Planning Commission Hearing Staff Report

McDonald's Design Review for Rebuild
Conditional Building and Site Design Review
(Petition 430-08-01)
1533 South State Street
Hearing date: June 11, 2008

SITE PLAN IMPROVEMENTS

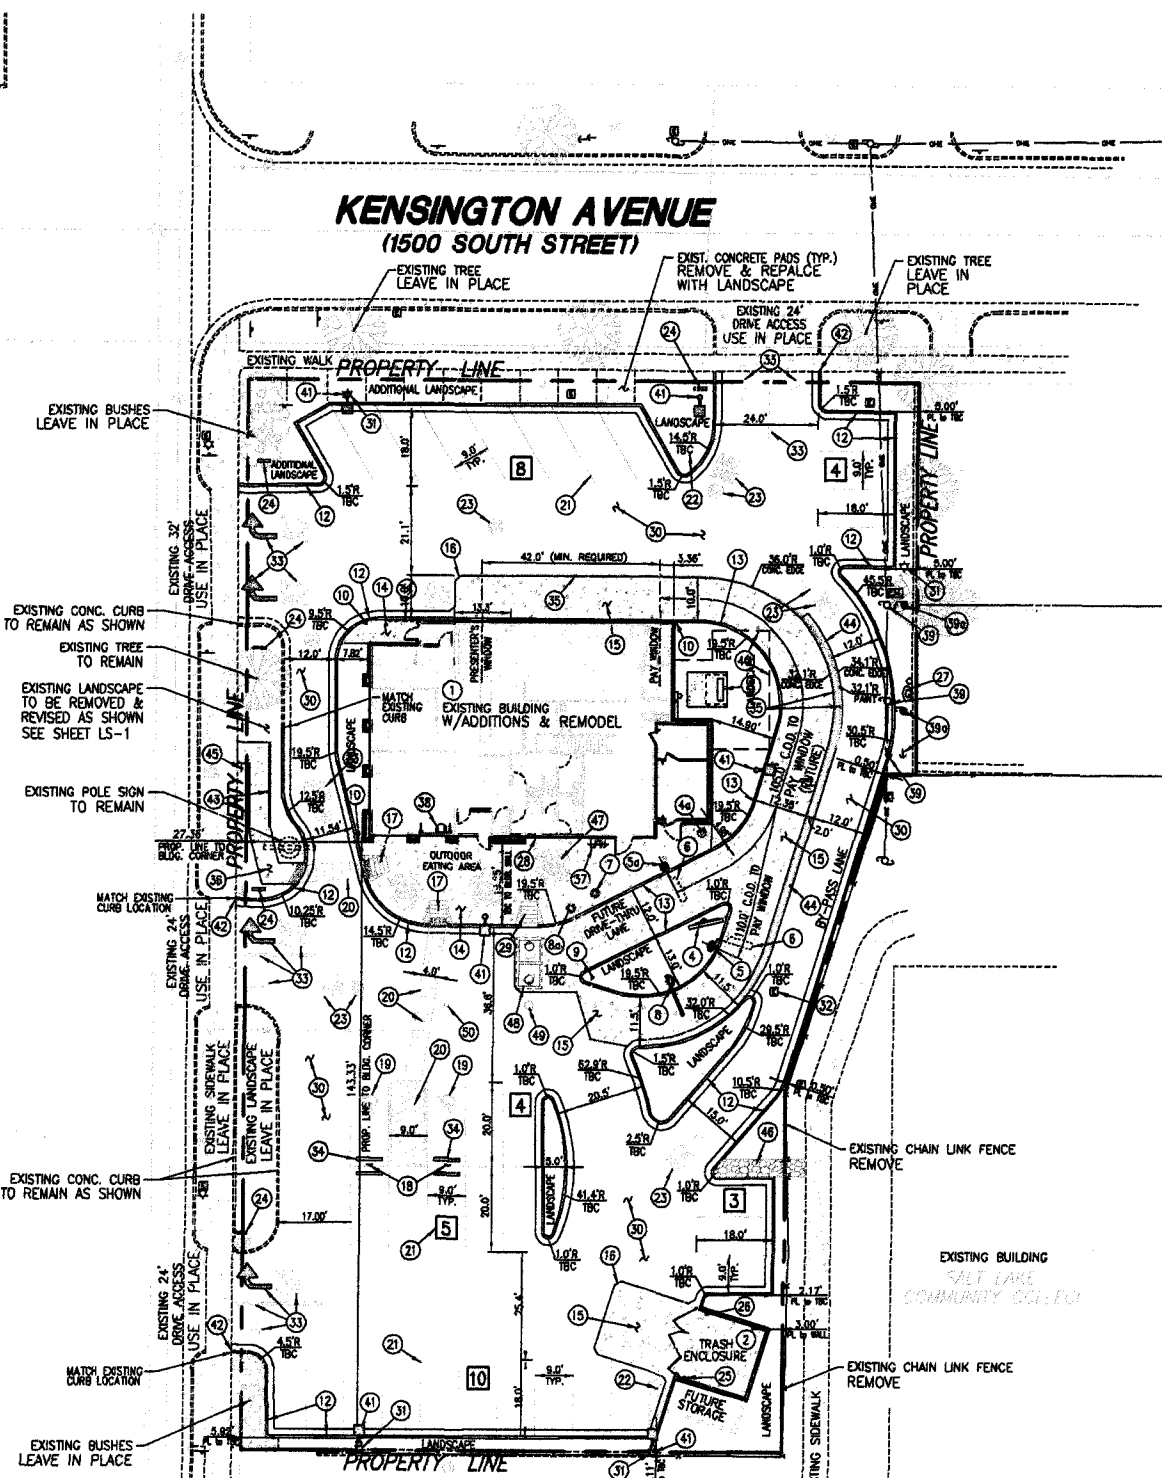
- **Parking Setback (21A.34.090.D.3):** The SSSC overlay district prohibits parking in the front and corner side yards. In this case, parking stalls are proposed to be located in the extreme northwest and southwest corners of the site, which conflict with the front yard along State Street. Proposed parking is also located within the corner side yard, which is along Kensington Avenue. Parking for the project will be located both north and south of the proposed building. The parking lot extends over three parcels, which should be combined as a condition of a project approval to avoid complications with off-site parking and perimeter parking lot landscaping requirements for each of the separate parcels.

Relief from the parking setback requirement in the front yard (State Street) is not necessary. One parking stall in the northwest corner and two stalls in the southwest corner could be converted to landscaped areas. As mentioned previously, the proposed number of parking stalls is more than required and eliminating up to ten to accommodate additional landscaping or rotating of the building is preferred. The parking proposed within the corner side yard (Kensington Ave) is realistically the only area available to park north of the proposed building and still provide sufficient backing clearance between the parked vehicles and those using the drive-through lane.

- **Number of parking stalls (Section 21A.44.060):** The proposed number of parking stalls exceeds the minimum number required. 34 stalls are proposed but, based on the building floor area of 3,862 square feet shown on site plan; the number of required parking stalls is 24 (6 per 1000 sq. ft. building area). For outdoor dining areas, no additional parking is required unless the seating capacity is being increased by more than five hundred (500) square feet. Parking for outdoor dining areas in excess of five hundred (500) square feet is required at a ratio of three (3) stalls per one thousand (1,000) square feet of outdoor dining area. This requirement may be waived if part of a Conditional Building and Site Design Review. The area of the proposed outdoor dining is approximately six hundred (600) square feet and accommodates three tables.

- **Perimeter Parking Lot Landscaping (21A.48.070.C.2):** When parking is proposed within a required yard or within twenty feet (20') of a lot line, perimeter landscaping shall be provided. The landscaping shall be provided with landscape areas at least seven feet (7') wide measured from the back of the parking lot curb. The proposed parking lot extends into the front yard (State Street) at the extreme northwest and southwest corners; into the corner side yard (Kensington) along the north boundary, and; is within 20 feet of the rear (east) and interior side (south) property line. The proposed landscape areas along State Street, except the extreme southwest corner, satisfy the seven (7') foot minimum. The remainder of the perimeter parking lot landscaped areas range between three (3') and four (4') feet in width.

In this case, the excess parking is not needed. Between seven (7) and ten (10) stalls, depending on the size of the outdoor dining area, could be removed and the parking lot layout revised to increase the width of the perimeter landscaped areas to 7 feet in the extreme southwest corner and the two parking areas along the east property line. Given the small size of the parking area north of the building, and the existing landscaped park strip, staff supports the requested reduction of the perimeter landscape buffer along Kensington Avenue.

The parking calculations indicates that there were 51 parking spaces and now only 32 are being provided. Revise the parking calculations as need to be presented for the entire site (building sf and out door dinning over 500 sf) ? 22 to 25 stalls required. The ADA stalls (2) are shown with one being van accessible and the bike rack is noted but not calculated in the 5% requirement.

LANDSCAPE PLAN

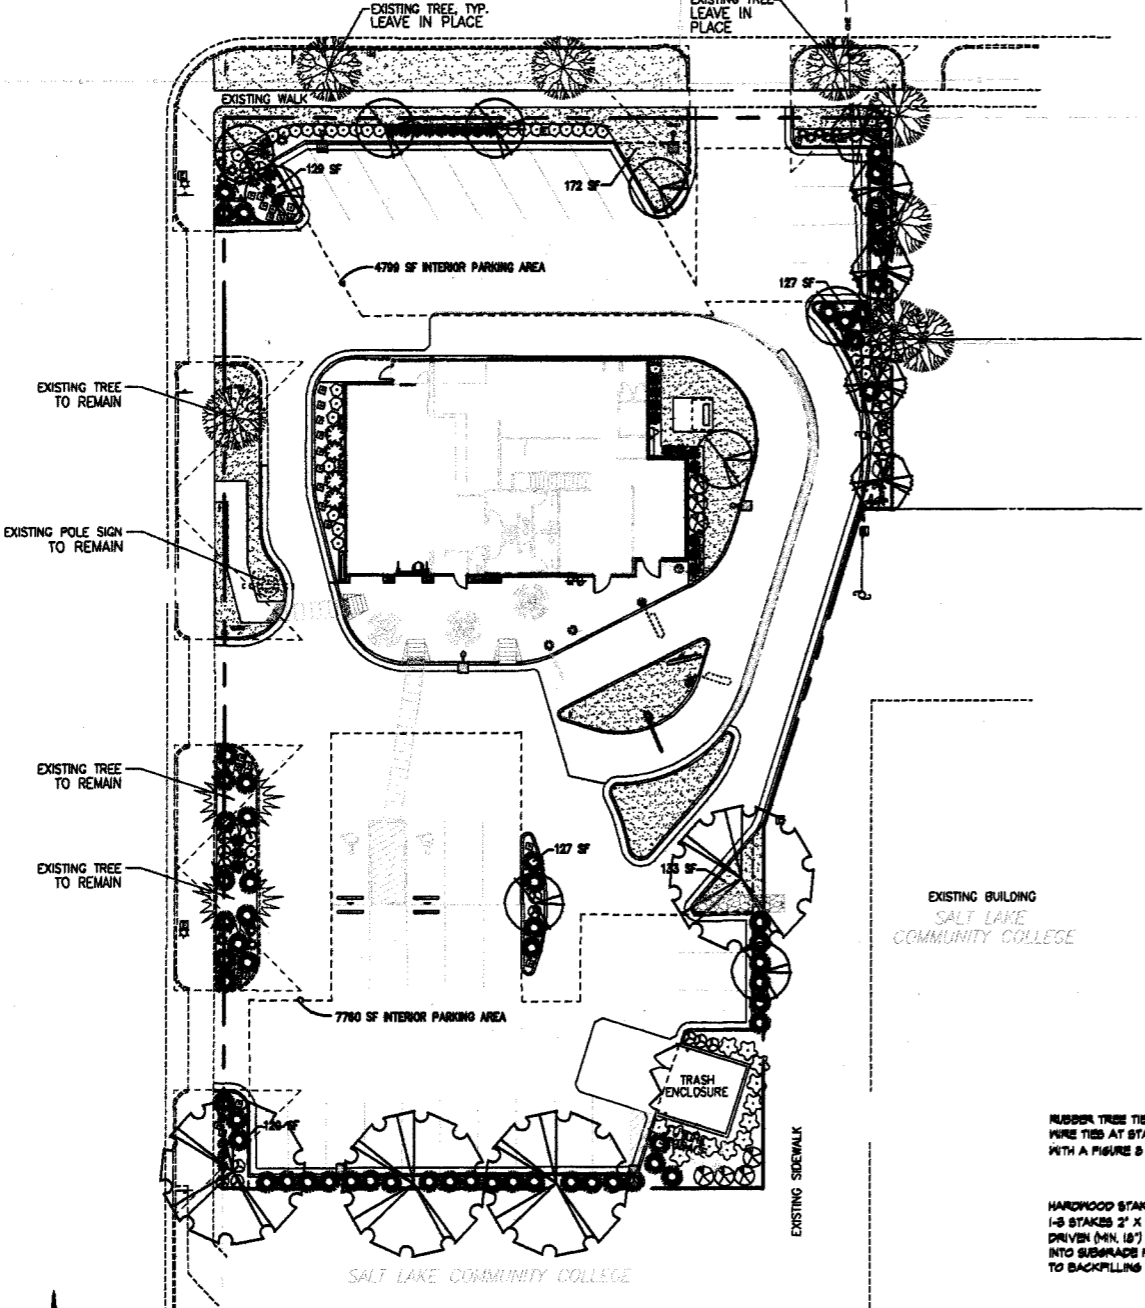
Analysis: The parking lots will be similar to the existing design, with some modifications to enhance the drive-through system and increase landscaping on the site. The perimeter parking lot landscaping along State Street and Kensington will be enhanced with additional shade trees and more shrubs in sufficient quantity to meet the landscaping requirements. The total amount of landscaped area will increase by approximately 1,800 square feet (3,944 sq ft to be increased to 5,736 sq ft). The redevelopment does not provide sufficient landscaping buffer width on the east lot line near the residentially zoned lots owned by the Salt Lake Community College or south property line. The Landscaping Ordinance stipulates a 7-foot perimeter parking lot buffer whenever the parking lot is within 20 feet of property lines. The landscape buffer proposed is approximately four feet. The existing site does not meet the ordinance but, with the redevelopment, will come closer to meeting the ordinance. The improvements and enhancements proposed by the applicant will increase the screening of the parking lot and increase the total amount of landscaping on the site.

North
A ELEVATION
 SCALE: 1/4" = 1'-0"
 Kensington Ave.

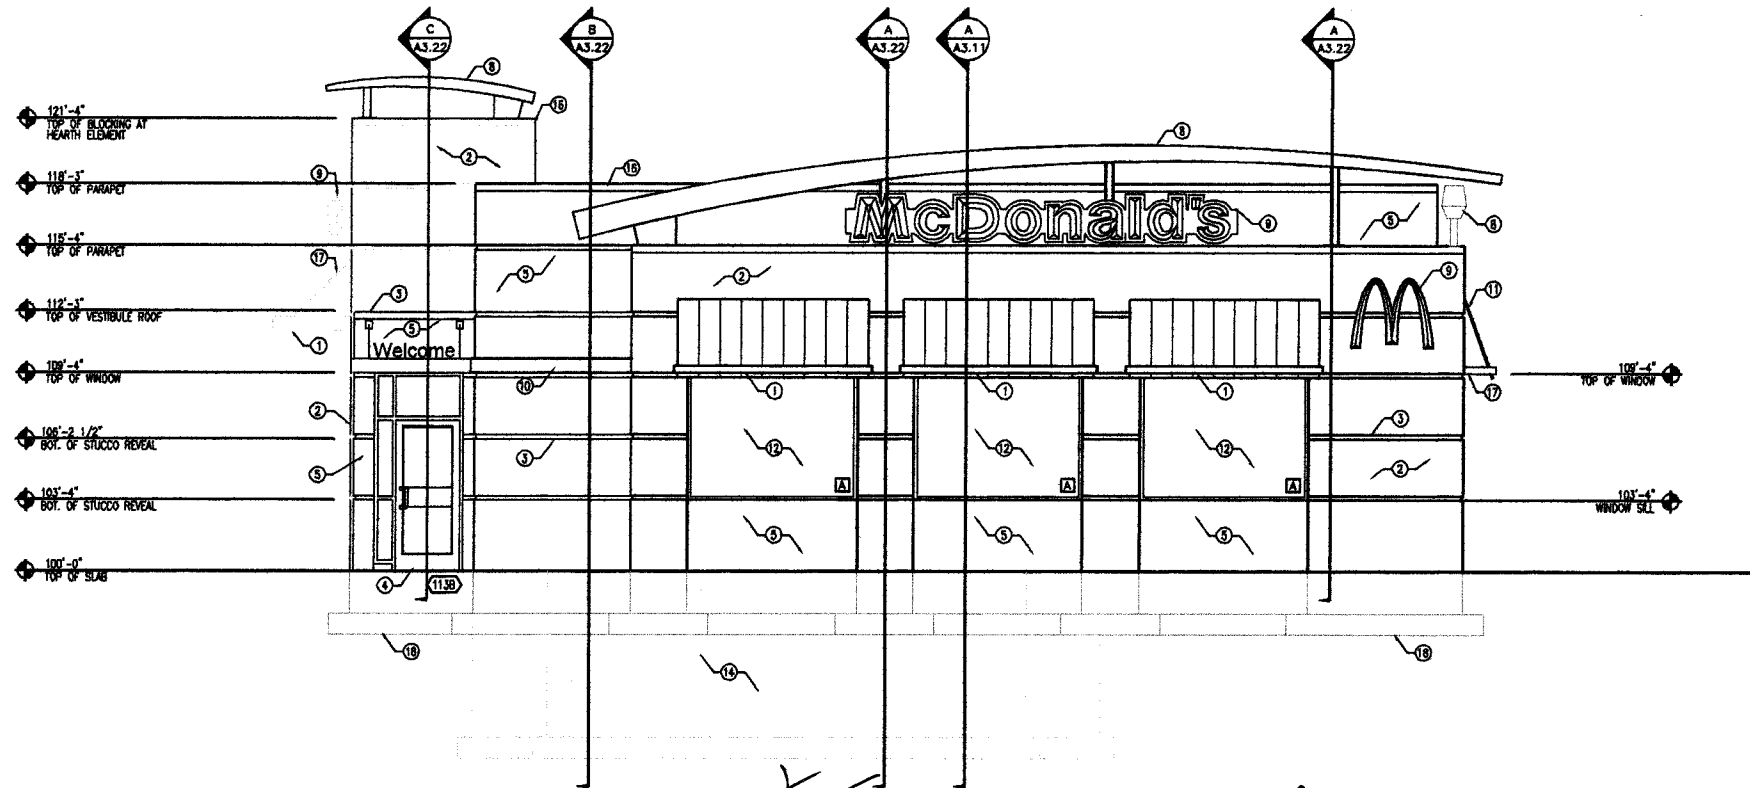
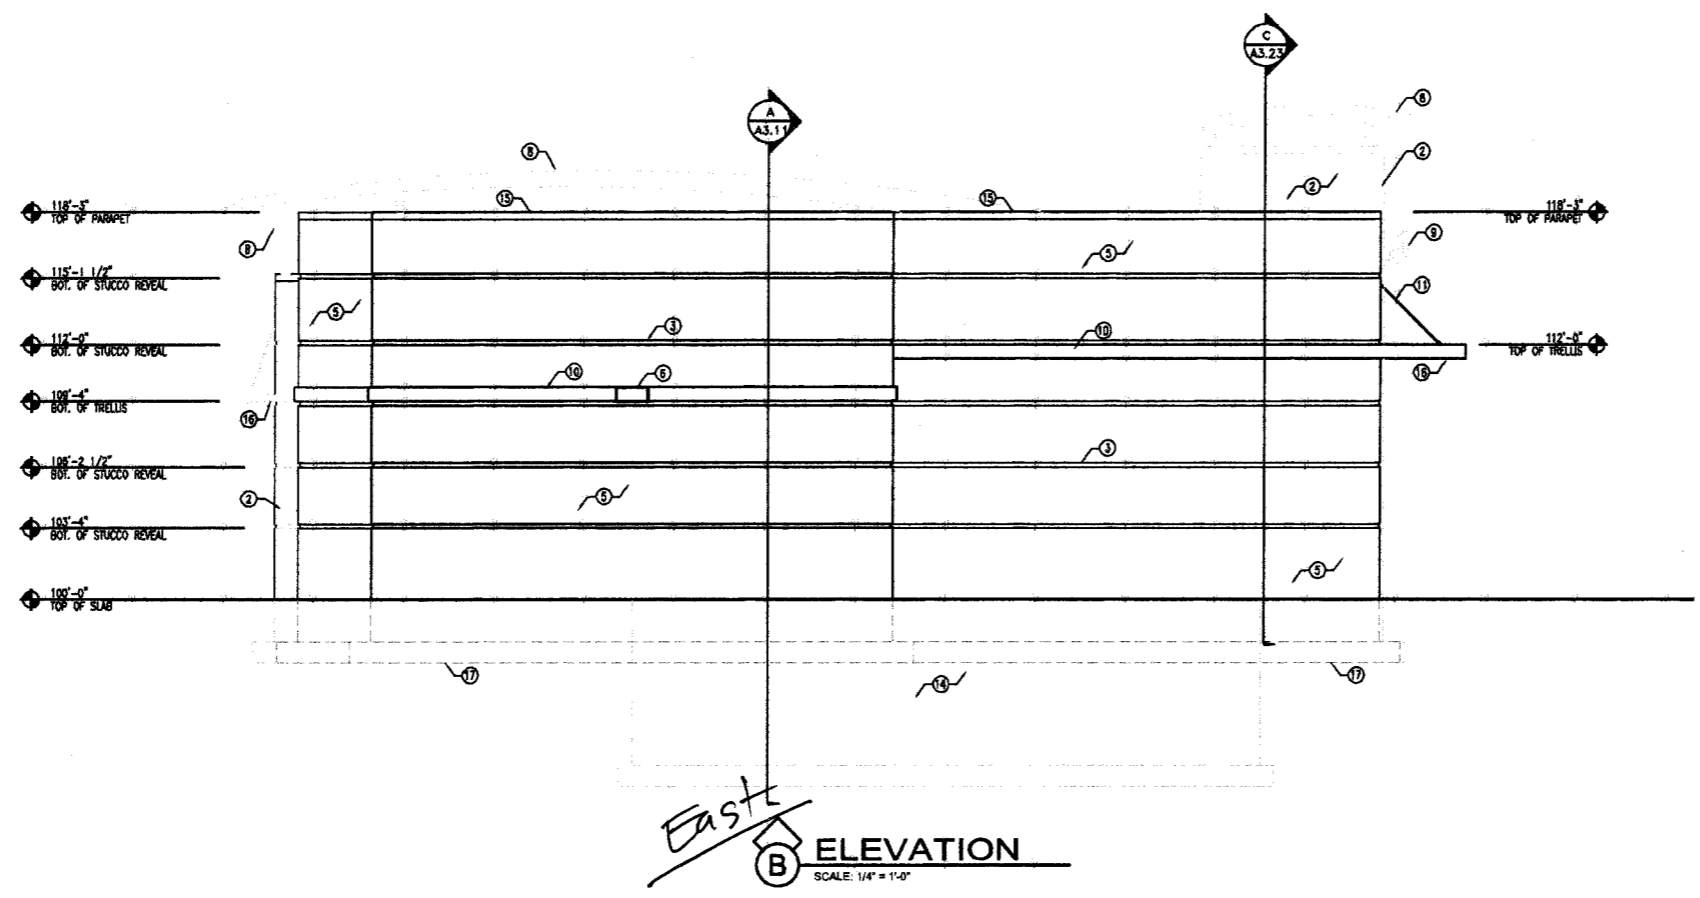
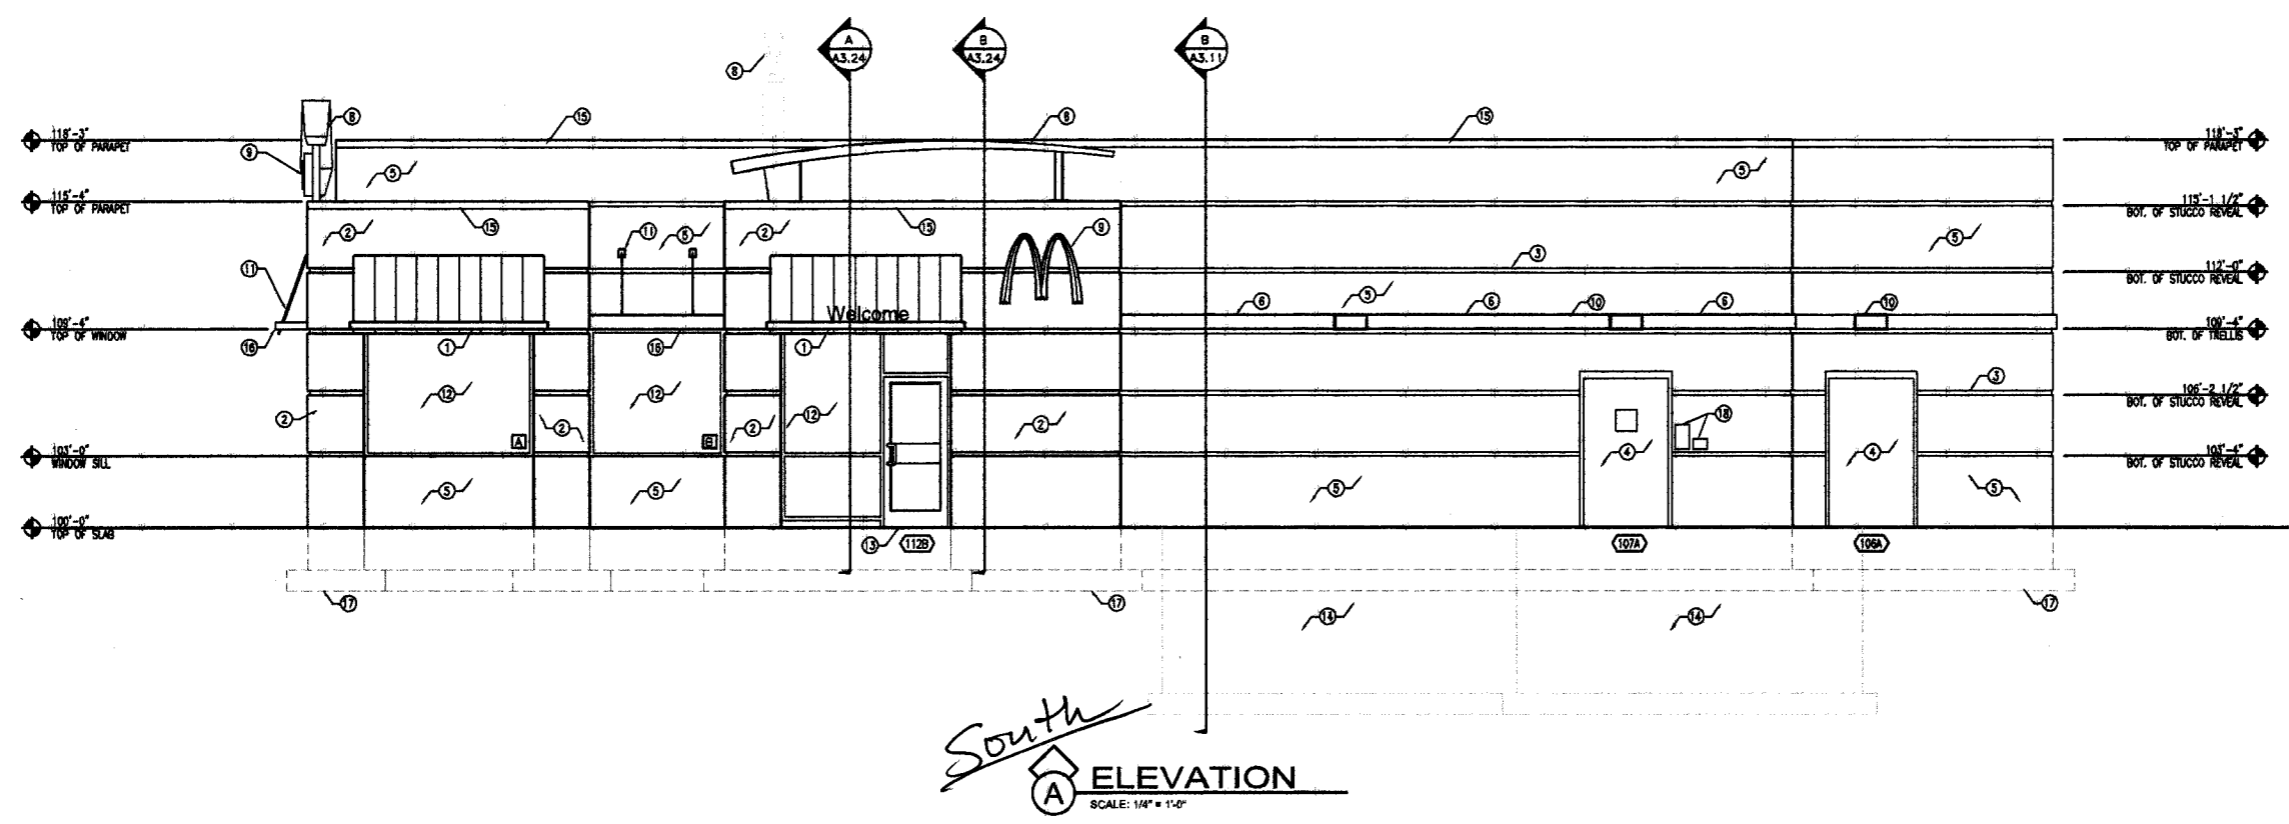
- **Minimum First Floor Glass (21A.34.090.F.1):** The building facades facing State Street and Kensington are required to have a minimum of forty percent (40%) non-reflective glass. The proposed façade along Kensington Avenue, which is the drive-through side of the building, has approximately seven percent (7%) glass. The proposed façade along State Street has approximately eighteen percent (18%) glass.

Staff concedes that adding more windows along the drive-through lane façade lacks any real purpose. However, staff finds no hardship preventing 40% glass content on the west façade (State Street). In considering the aforementioned option of rotating the building and locating the drive-through lane on the east façade, the applicant could provide more glass content on the north (Kensington) and west (State Street) facades. This would be one more aspect whereby the project meets the intent of the SSSC Overlay and conforms to current ordinances.

Analysis: The front façades of the proposed building will consist mainly of stucco and stone with customer entrances on the south (State Street) and north (Kensington Ave) sides of the building. The rear portion of the building will consist of mainly stucco. Windows are proposed for the western portion of the building and will be located on the south, east, and north facades. The facades fronting State Street and Kensington Avenue are required to contain a minimum of 40% glass. The façade on State Street contains approximately 18% glass and the façade on Kensington Avenue contains approximately 7% glass. The proposed amount of glass, coupled with the awnings and stone do facilitate some pedestrian interest but do not clearly satisfy the ordinance. The Kensington façade has minimal pedestrian interest on purpose, as it is the vehicle drive-through. The interior kitchen facilities are located along the Kensington wall and requiring more windows along this drive-through wall is not as crucial as along State Street. No hardship was found that would prevent 40% percent glass on the façade along State Street.
